# UNITED STATES PATENT AND TRADEMARK OFFICE

APPLICATION NO.	FILING DATE	FIRST NAMED INVENTOR	ATTORNEY DOCKET NO.	CONFIRMATION NO.
10/004,980	12/07/2001	James H. Lee	H-204145	1793

## Office Action Summary

## **DETAILED ACTION**

FIG. 1

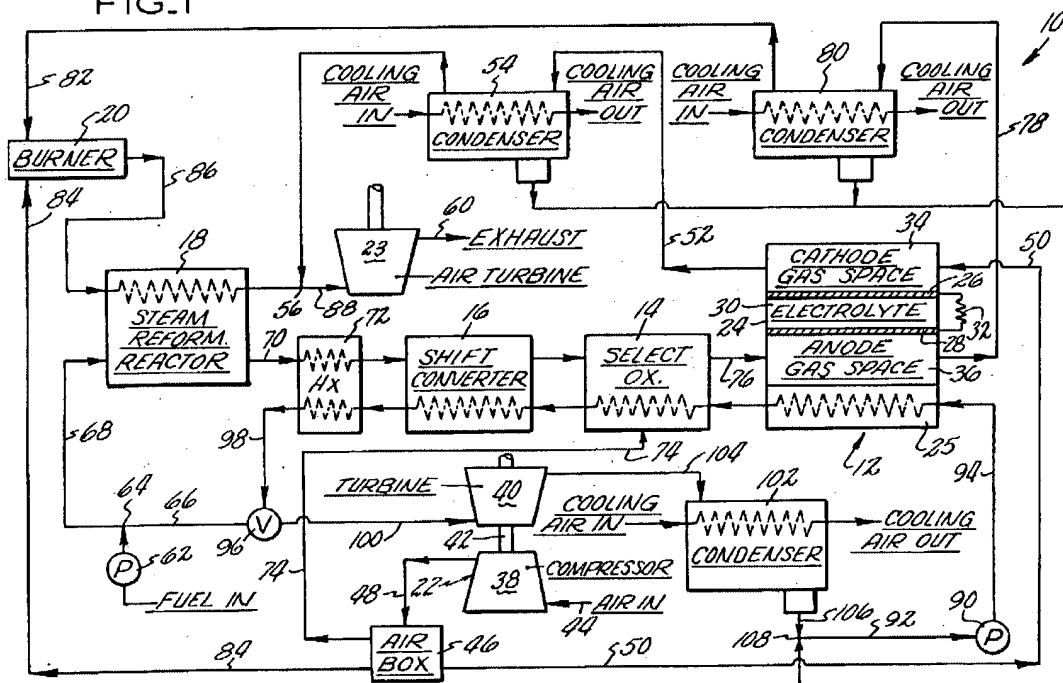
Bloomfield discloses a fuel cell power plant (TITLE) comprising as shown in **Figure 1** below a pump 90 delivering water via a conduit 92 into thermal exchange relationship with stack 12 via a conduit 94 by passing the water through the thermal exchange portion 25 of the stack (COL 5, lines 28-32). It is disclosed the fuel cells comprises a single cell 24 and a thermal management portion 25 (COL 3, lines 23-27). Bloomfield discloses that the liquid is increased in pressure by pumps (COL 4, lines 1-5). Bloomfield further discloses that part of the water is changed to steam as it passes through the stack 12. The water and steam is superheated by passing it into heat exchange relationship with the fuel conditioning apparatus. It is further heated in the selective oxidizer 14 and the shift converter 16 and in the heat exchanger 72 (COL 5, lines 32-40). The steam then leaves the heat exchanger 72 and is delivered to a valve 96. Then, the remainder of the superheated stream is delivered into turbine 40 (the expander) via a conduit 100. The turbine drives the compressor 38 for compressing the air for the stack. The turbine is a steam driven turbine, however, any steam driven engine operably connected to run a compressor may be used (COL 5, lines 40-50).

Bloomfield further teaches that the exhaust from the turbine 40 is delivered into a condenser 102 via a conduit 104. Heat is removed from the steam by passing air through the condenser as shown. Liquid water, or possibly a mixture of liquid water and steams, leaves the

condenser 102 via a conduit 106 and is combined at 108 with water recovered from the anode and cathode effluent gas streams in the condensers 54, 80. The water is then delivered to the pump 90 via the conduit 92 and the process starts again (COL 5, lines 50-62). It is disclosed that the amount of water lost in the Rankine cycle loop is recovered in the condensers 54, 80 and which is combined at 108 with the water which recirculates through the loop (COL 6, lines 1-6).

Hence, Bloomfield teaches the specific pump, heat generating fuel cell system, expander, the compressor (the second fuel cell system component) and the condenser satisfying the specific spatial relationship and functional configuration as instantly claimed.

**Examiner's note:** with respect to the organic liquid, Bloomfield clearly specifies that water recovered from the anode effluent gas streams in the condensers 54 or 80 is combined at mixing point 108 with the cooling fluid of the fuel cell power plant (COL 5, lines 50-62). Bloomfield also teaches that the anode gas stream effluent contains enough unburned gas
